PRELIMINARY STORMWATER REPORT

Normandy Heights

2007 Shaw Road
Puyallup, WA 98374

May 25, 2022
Our Job No. 12663

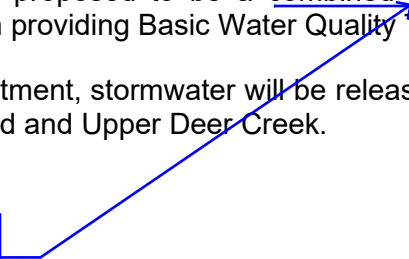
Should be identified on the predeveloped and post-developed basin maps. Note: the road widening should be modeled as Forest (converted surface area) in the predeveloped condition. In the post-developed condition, only a portion of the public ROW is tributary to the project site due to installation of the retaining wall.[Storm Report; Pg 24 of 211]

PREDEVELOPED BASIN MAP

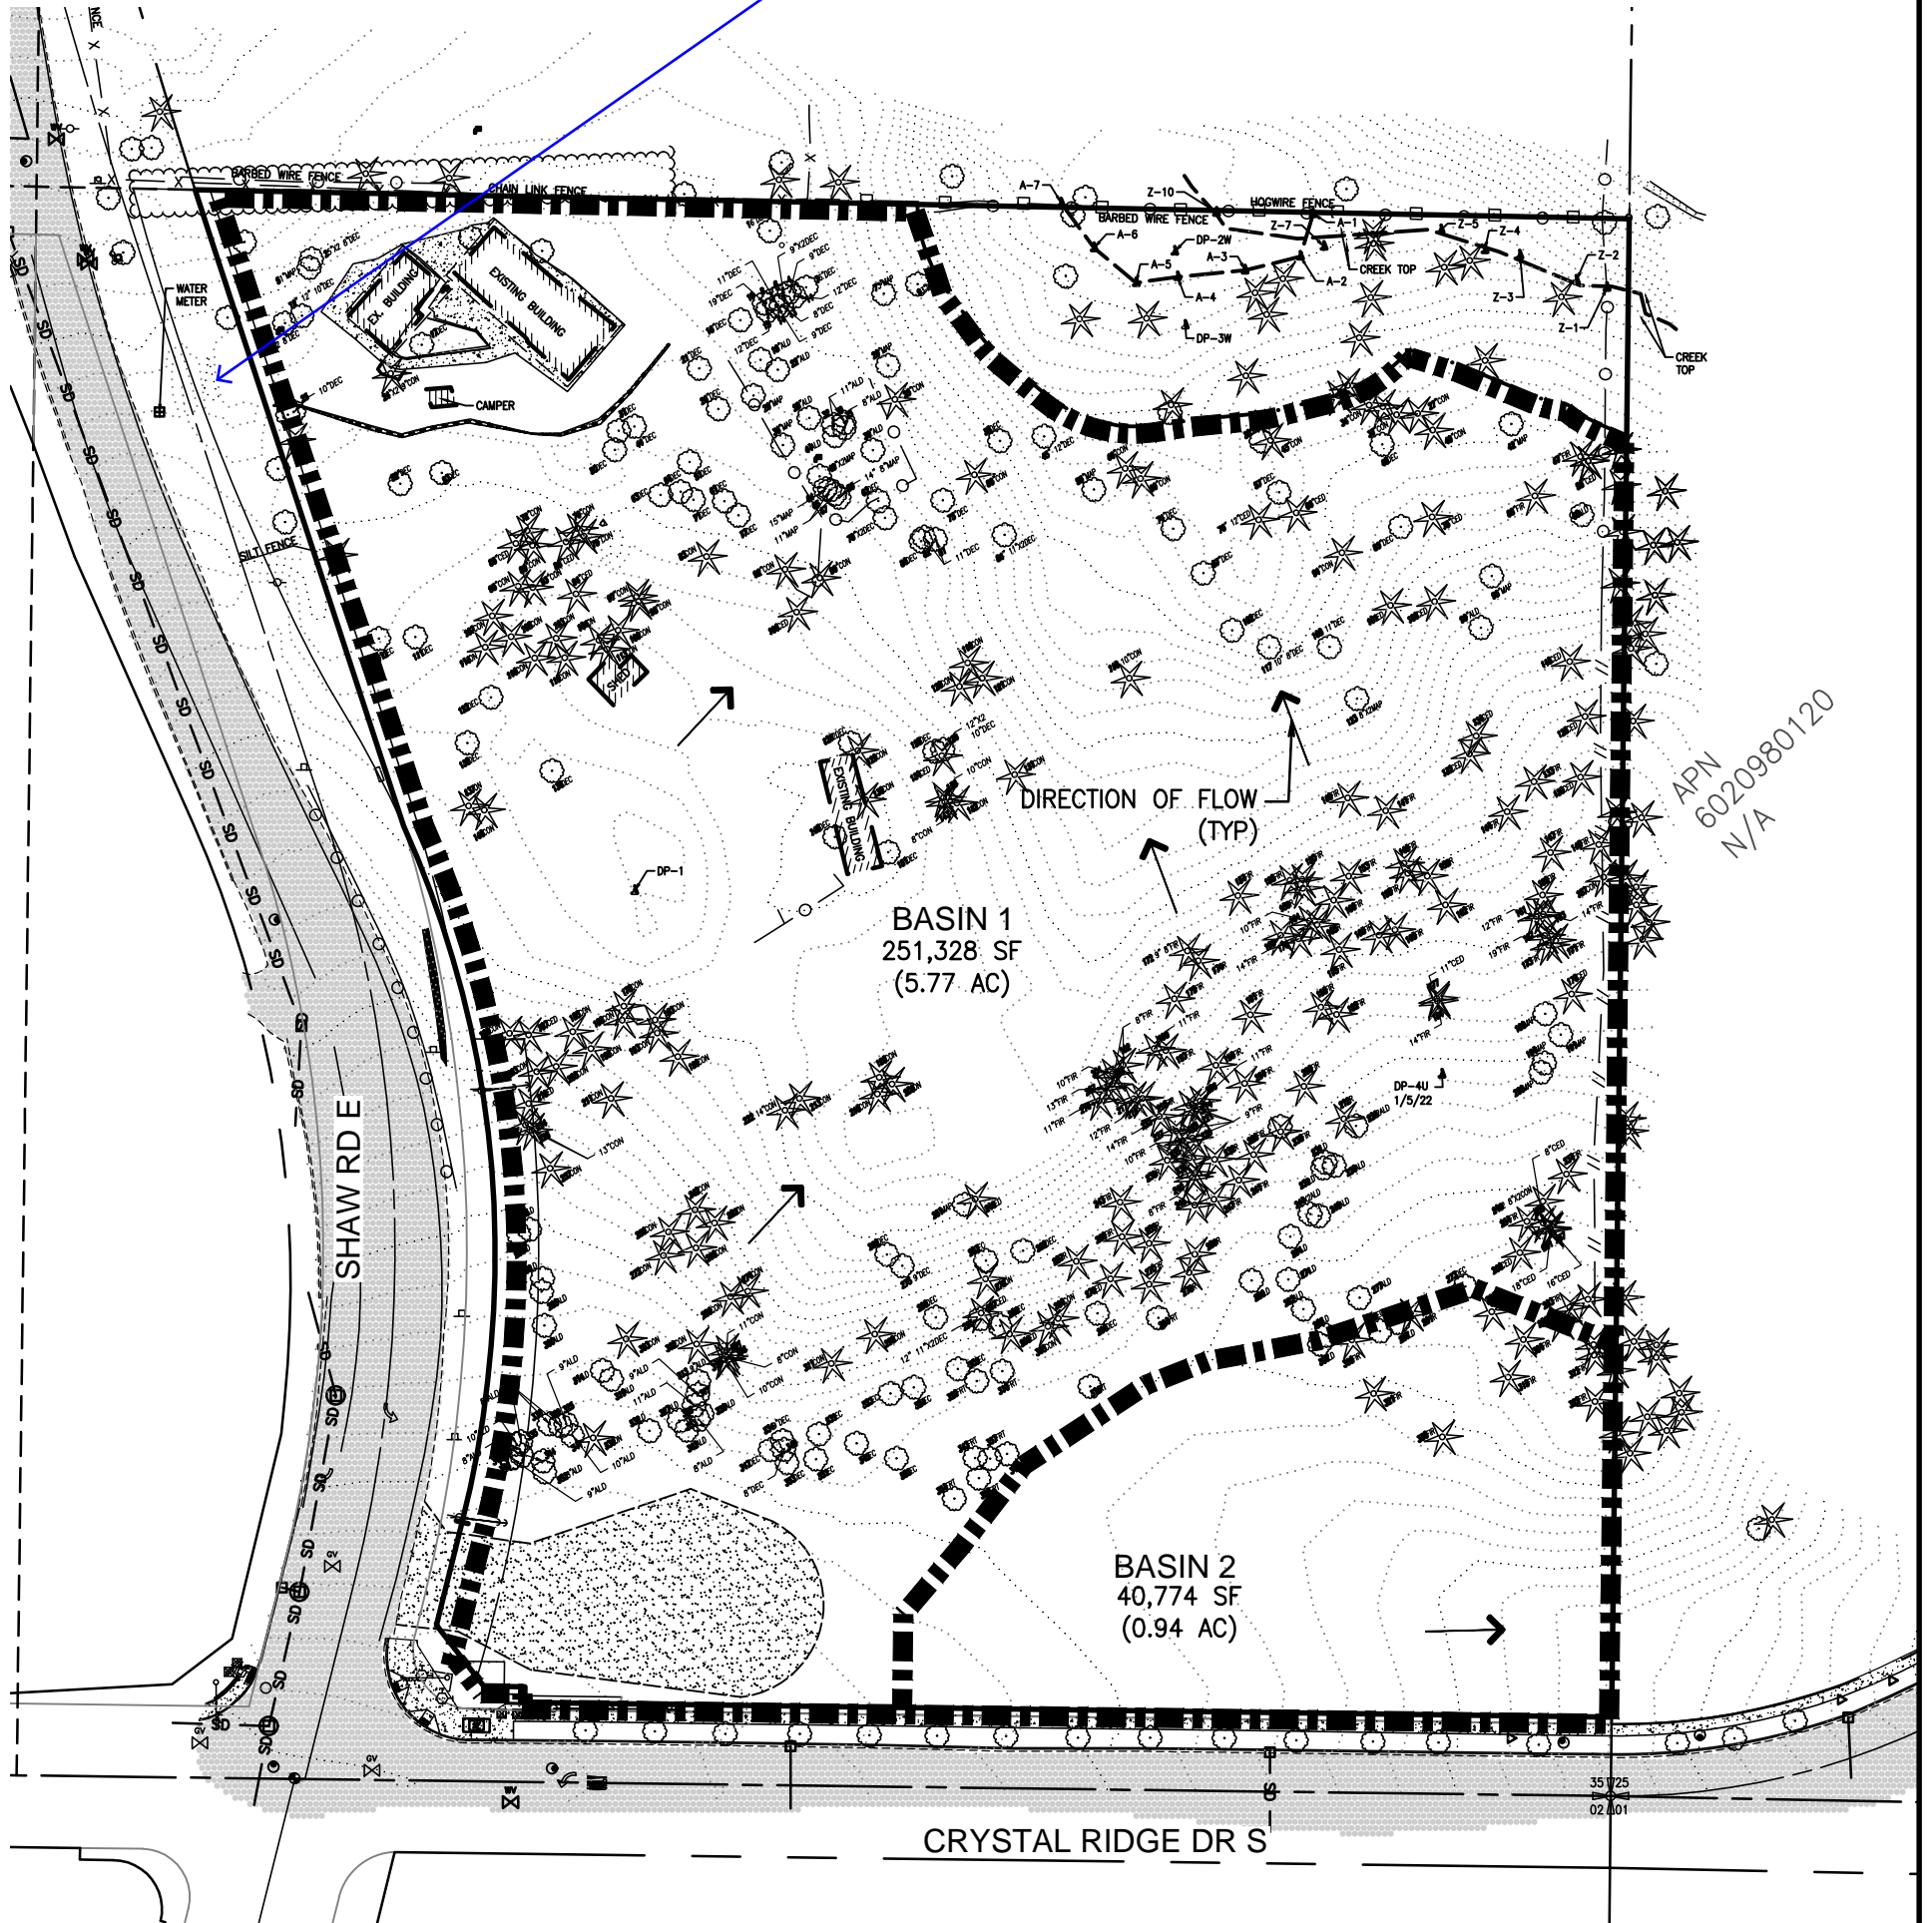
The road widening of Shaw Road (converted surface) must be included in the project thresholds and accounted for in the sizing of the stormwater facilities. (Storm Report; Pg 30 of 211)

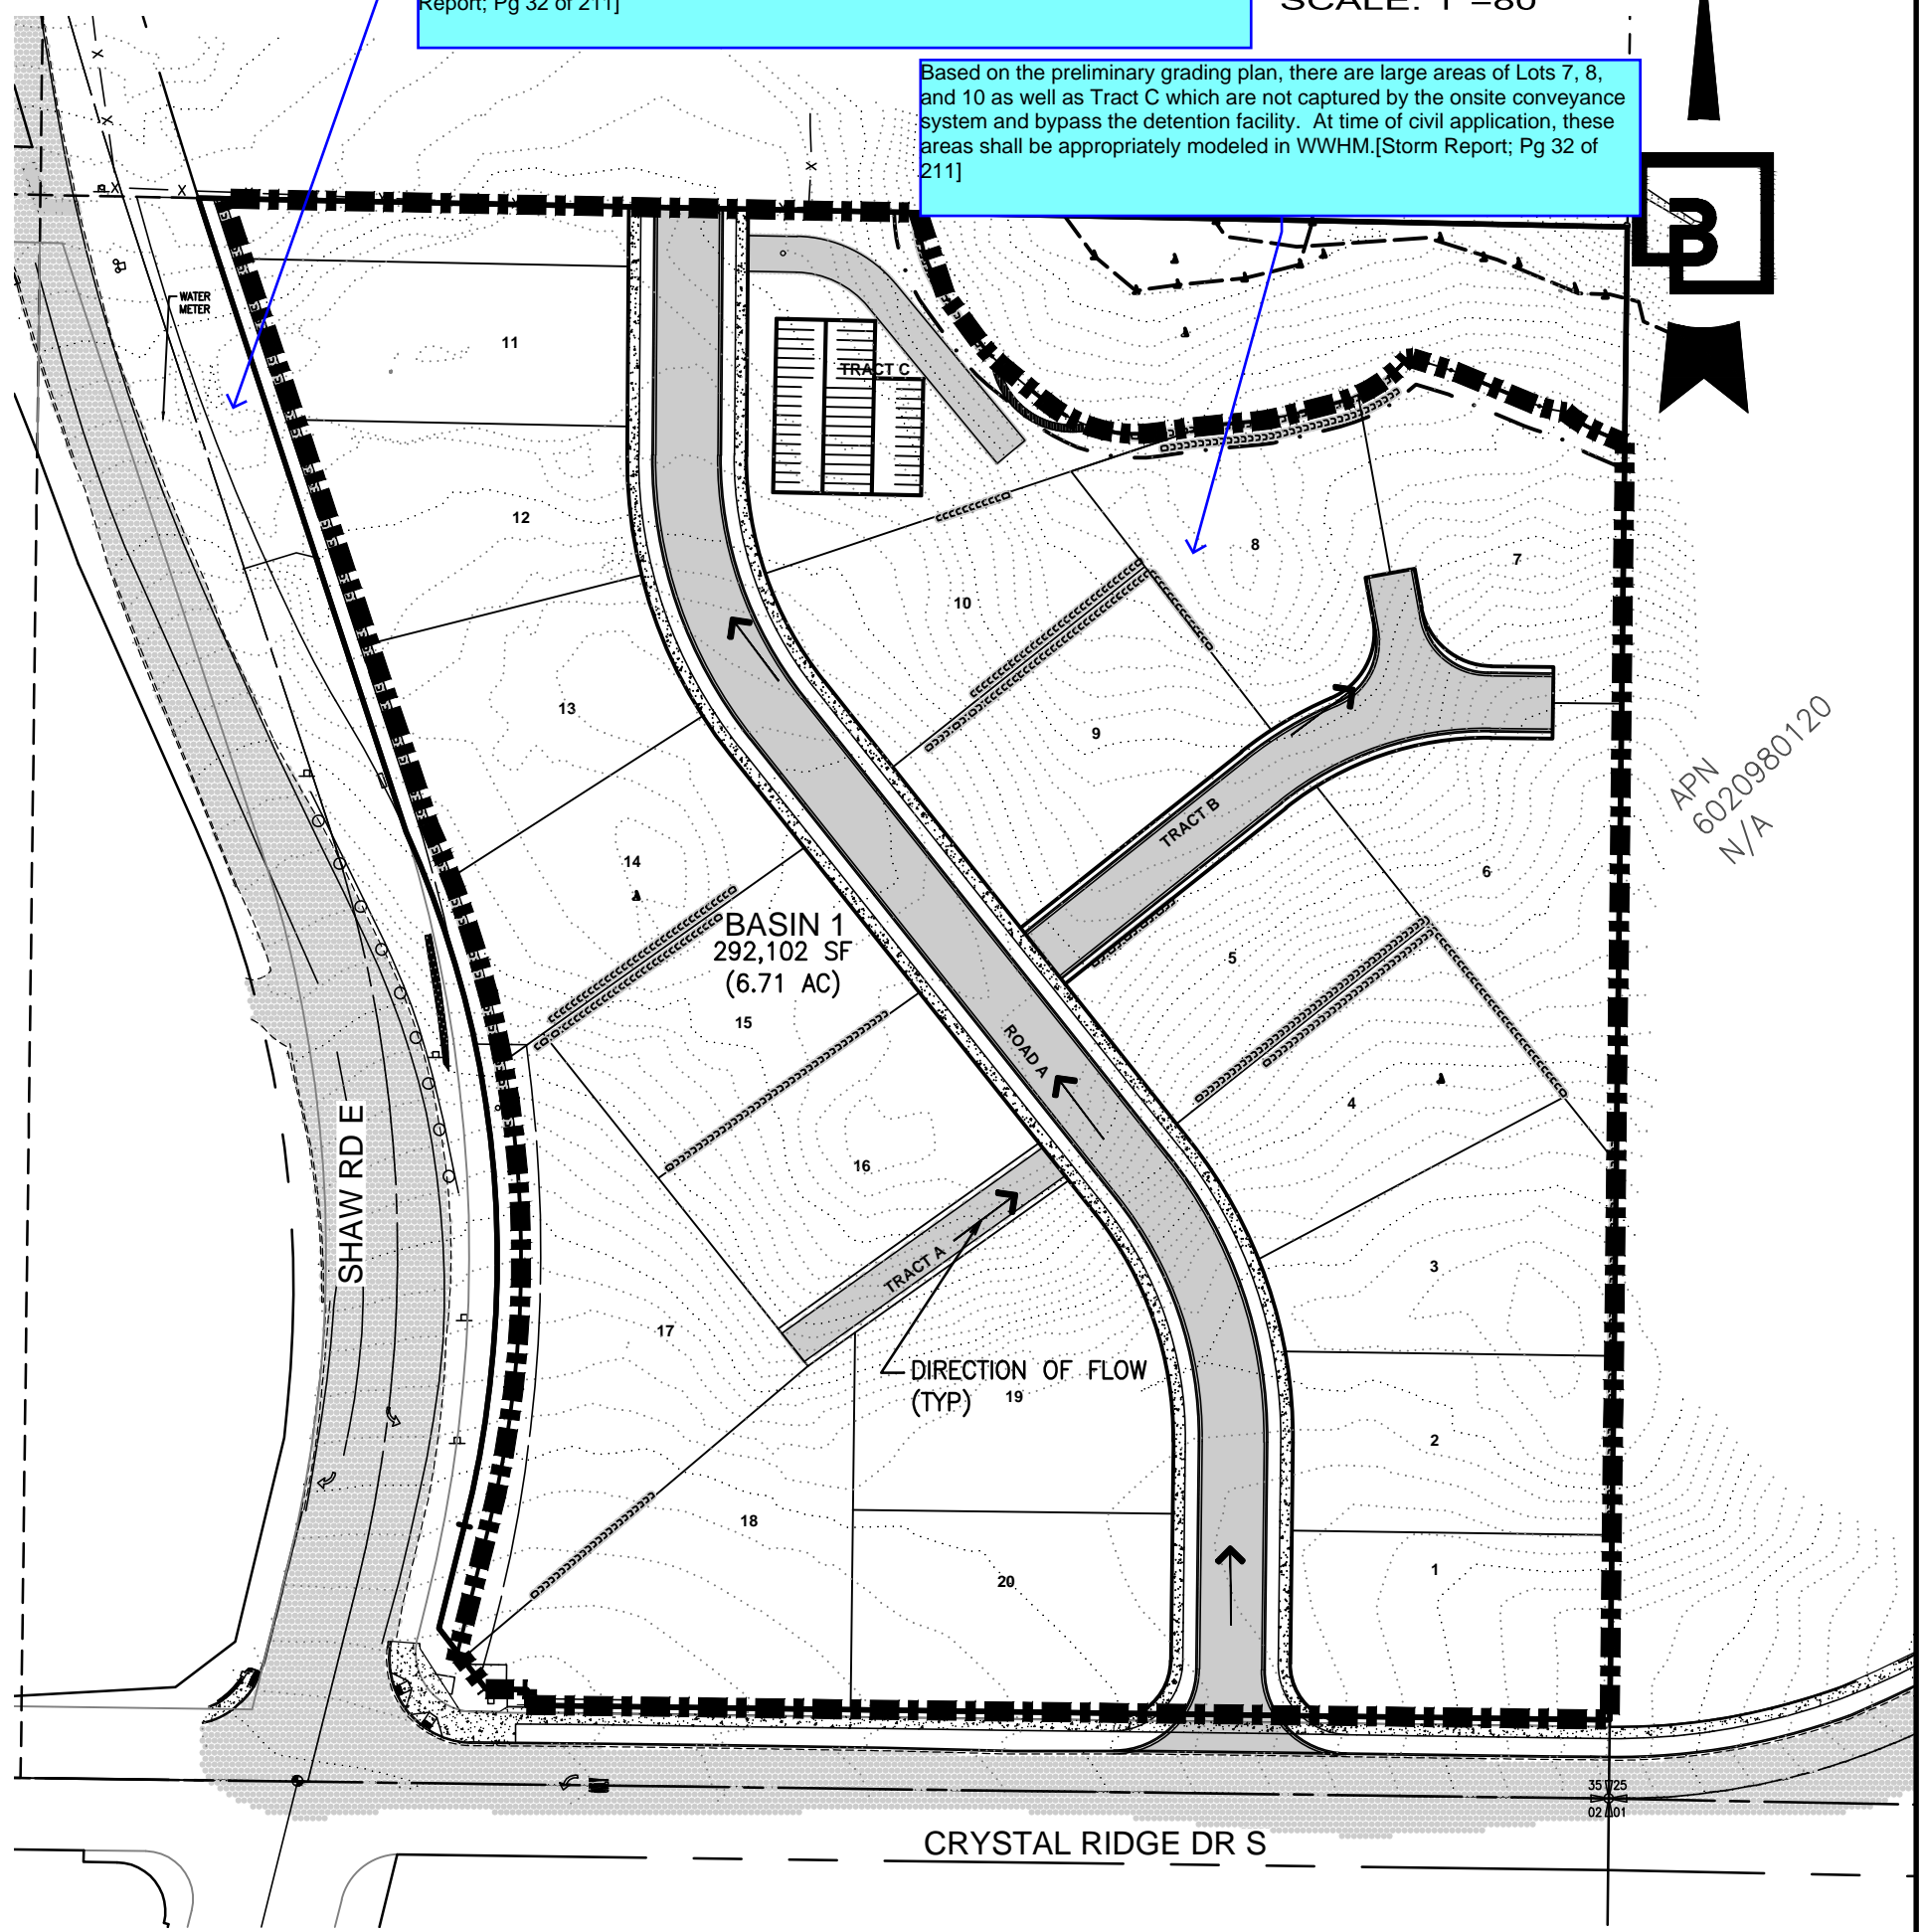
The road widening of Shaw Road (converted surface) must be included in the project thresholds and accounted for in the sizing of the stormwater facilities (bypass?). [Storm Report; Pg 32 of 211]

Based on the preliminary grading plan, there are large areas of Lots 7, 8, and 10 as well as Tract C which are not captured by the onsite conveyance system and bypass the detention facility. At time of civil application, these areas shall be appropriately modeled in WWHM. [Storm Report; Pg 32 of 211]

Figure V-2.1.1 Treatment Facility Selection Flow Chart

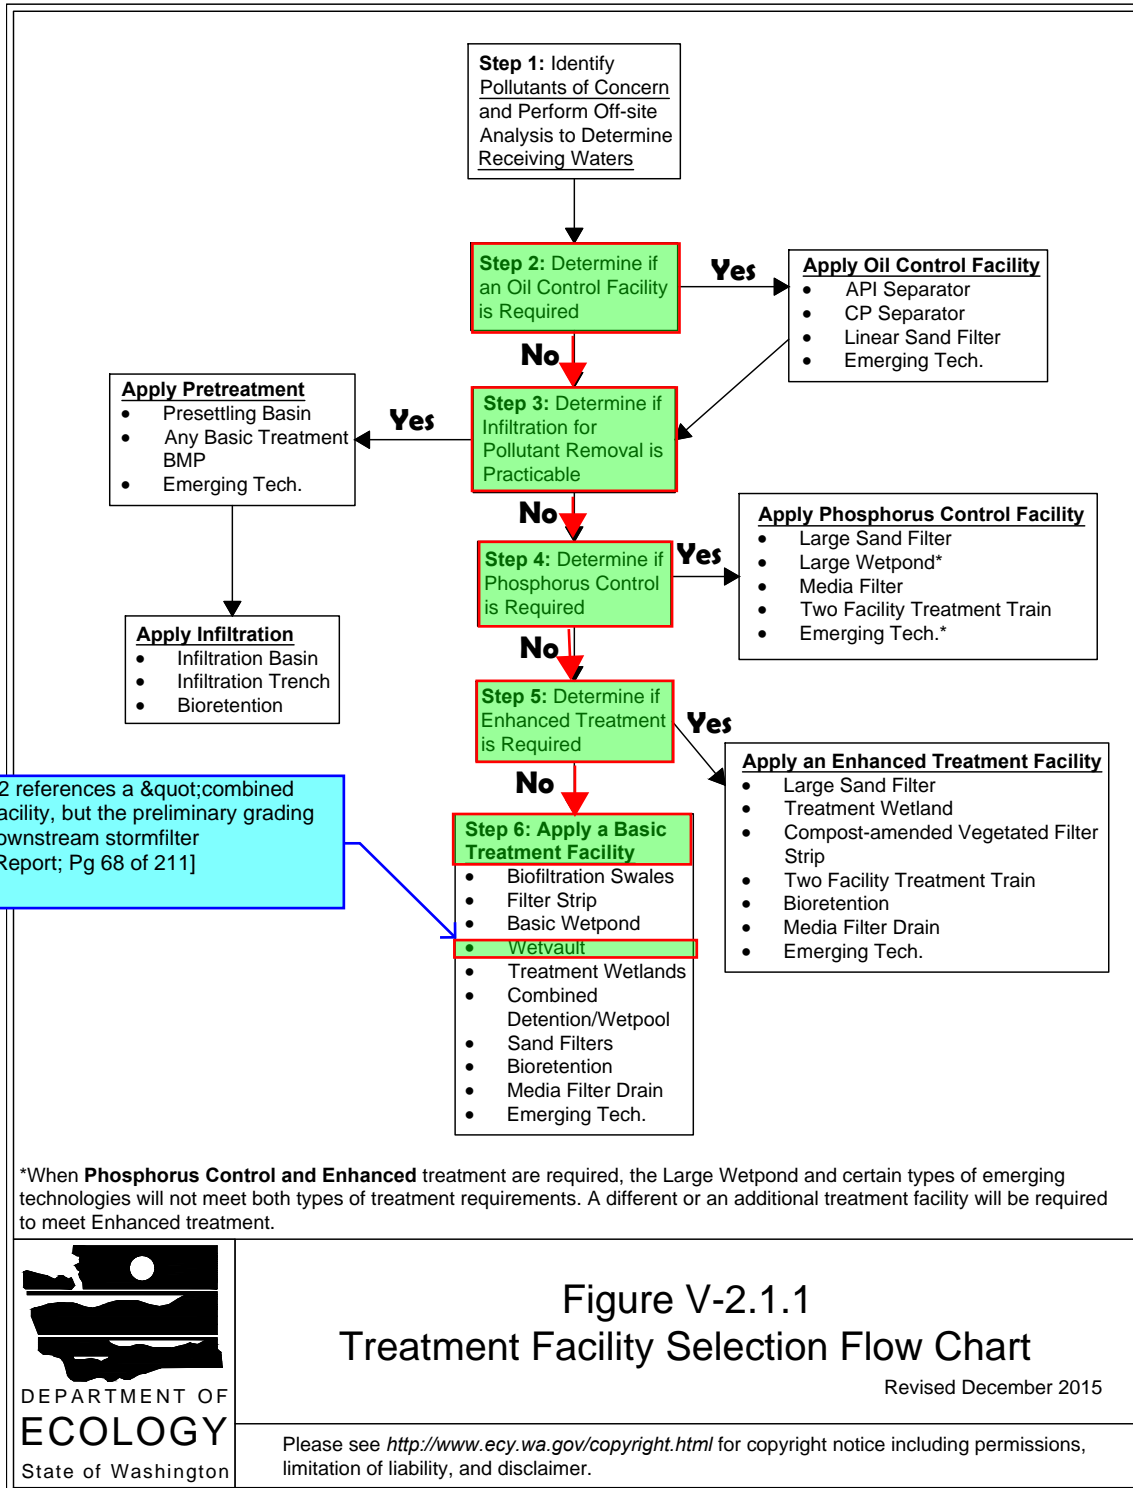
Section 5.2 references a "combined detention" facility and the Treatment Facility Selection Flow Chart (pg. 68) indicates a wetvault, but the preliminary grading plan calls out a downstream stormfilter structure. Revise accordingly.[Storm Report; Pg 27 of 211]
